Henry Lawson Drive Upgrade

Stage 1A

Addendum review of environmental
factors
November 2022

Figure 3-5 Proposed modification to the Tower Road Tie-in works and new compound site

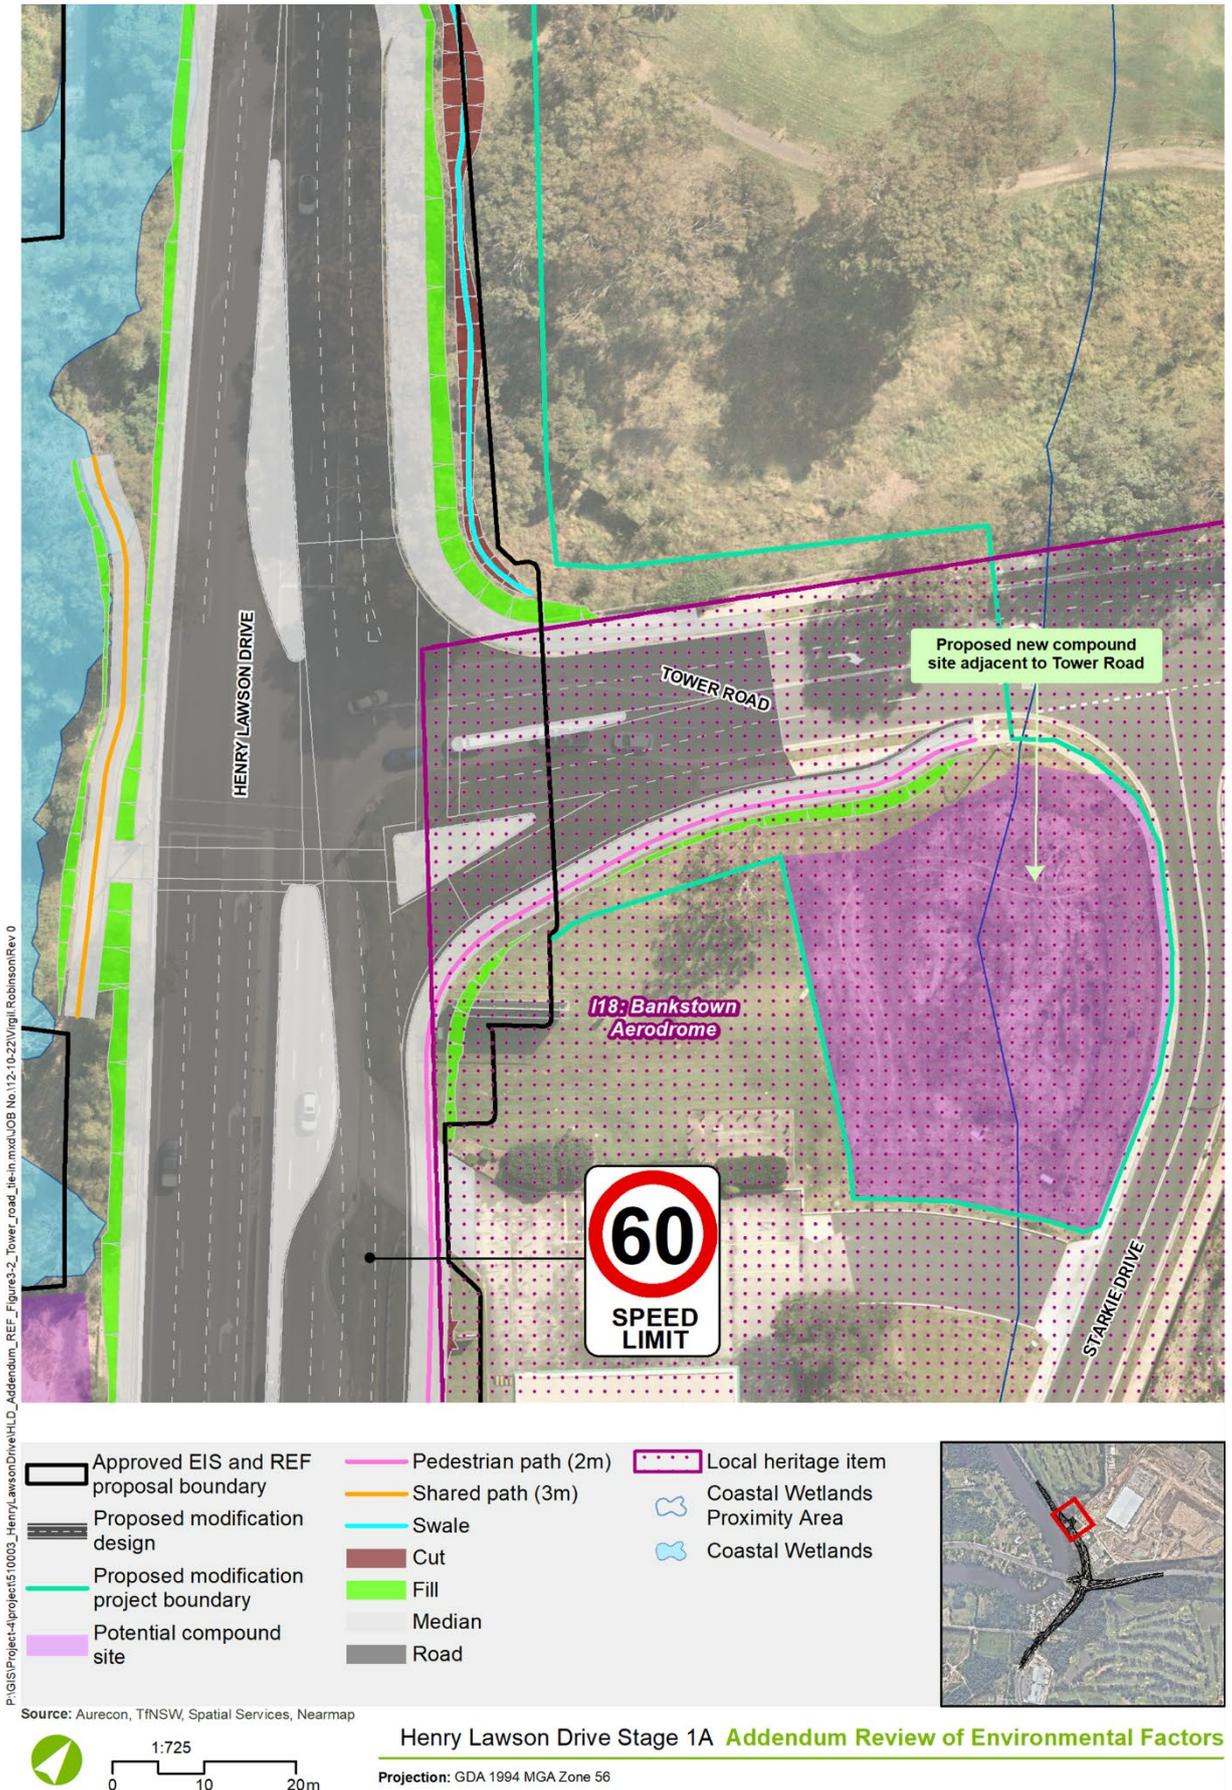
Works would involve minor realignment of kerbs and line marking, with works remaining within the project footprint. Refer to Figure 3-5 which shows the extension area from the project REF works.

The Tower Road compound site would be located on the corner of Tower Road and Henry Lawson Drive as identified in Figure 3-5. Comprising an area of 2209.11 square metres, the site is located on Lot231 DP1132273. It is located on cleared land, was previously used as a compound site for the Tower Road upgrade and is currently owned by Bankstown Airport Limited (BAL) under a head lease from the Commonwealth Government. Access/ egress from the Tower Road site would be via Starkie Drive to avoid queuing along Tower Road. The compound site would be returned to its existing condition following with the removal of demountable site offices, sheds, carparking, workshops and storage at the conclusion of works.

Figure 3-6: The proposed modification to the ALDI supermarket and retail area access

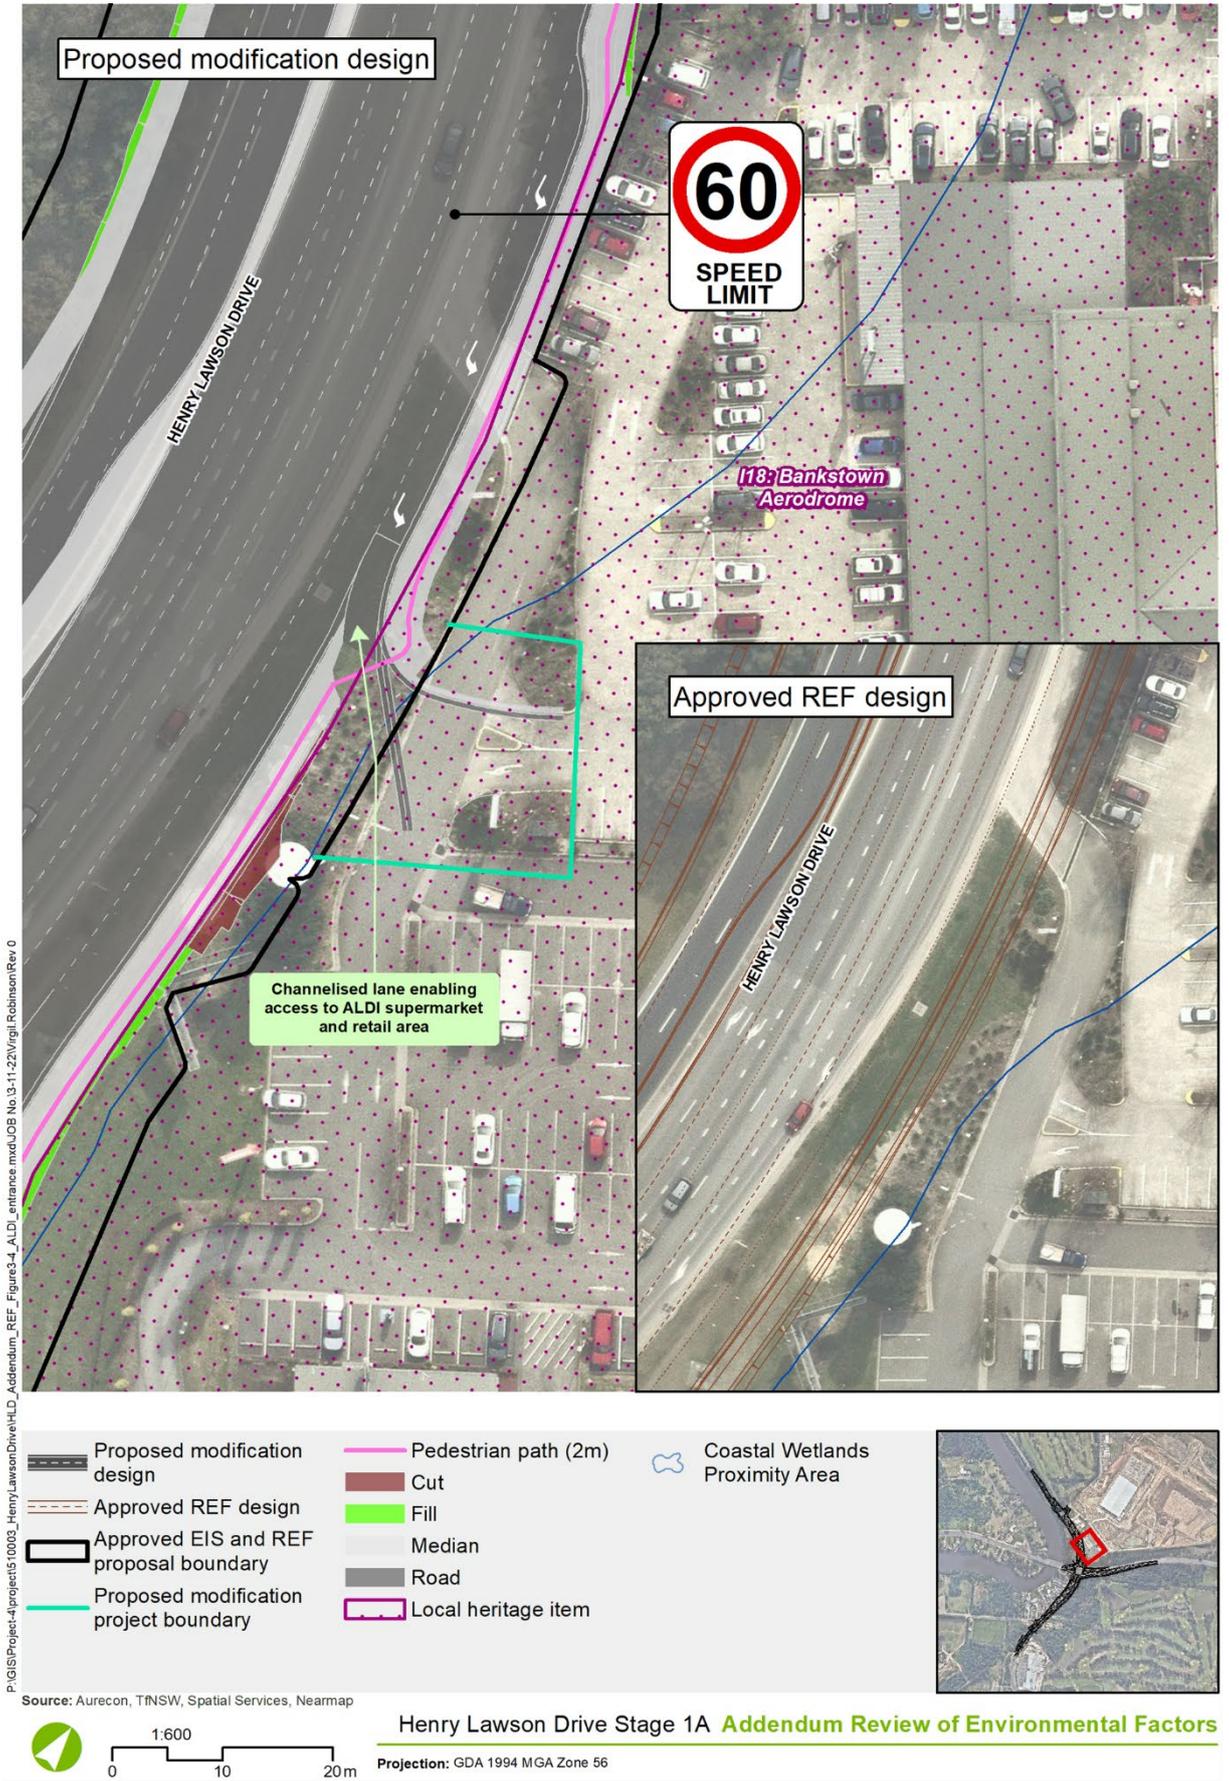
Road safety concerns were identified with this arrangement, with vehicles utilising the left turn lane to access Milperra Road potentially causing conflicts. The proposed modification would create a dedicated channelised lane connecting to the retail area driveway, enabling access to the Aldi supermarket site and retail area. This would involve some changes to the ALDI supermarket property to restructure some areas of parking. The proposed modification is shown in Figure 3-6.

Figure 3-8 Proposed additional property acquisition and lease

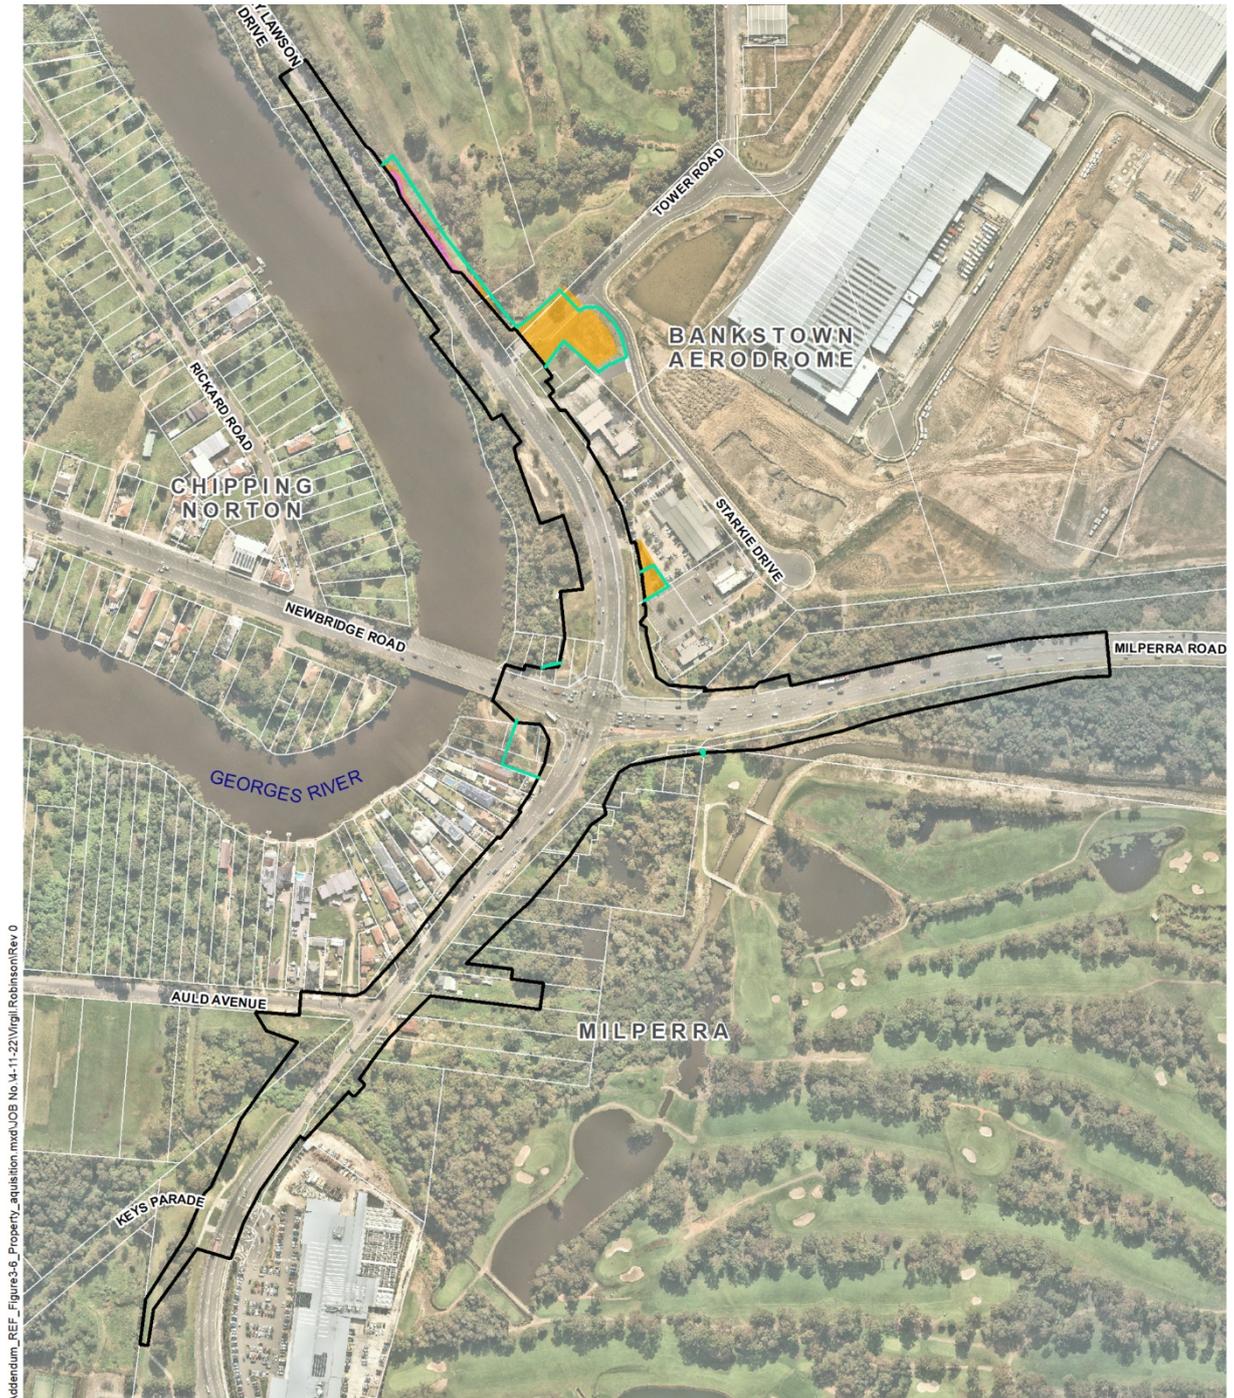
The proposed modification would require some small additional property acquisition and temporary lease of property as identified in Table 3-3 below. Property acquisition would involve about 14 square metres for the ALDI supermarket and retail area access on Commonwealth land (Lot 122/DP1037071). This land would be partially acquired due to construction of a new access road off Henry Lawson Drive and the remainder would require property adjustments. Additional property acquisition is required for Lot 2/DP1103168, Lot 1/DP433616 and Lot 2/DP213387 with further detail provided in Table 3-3.
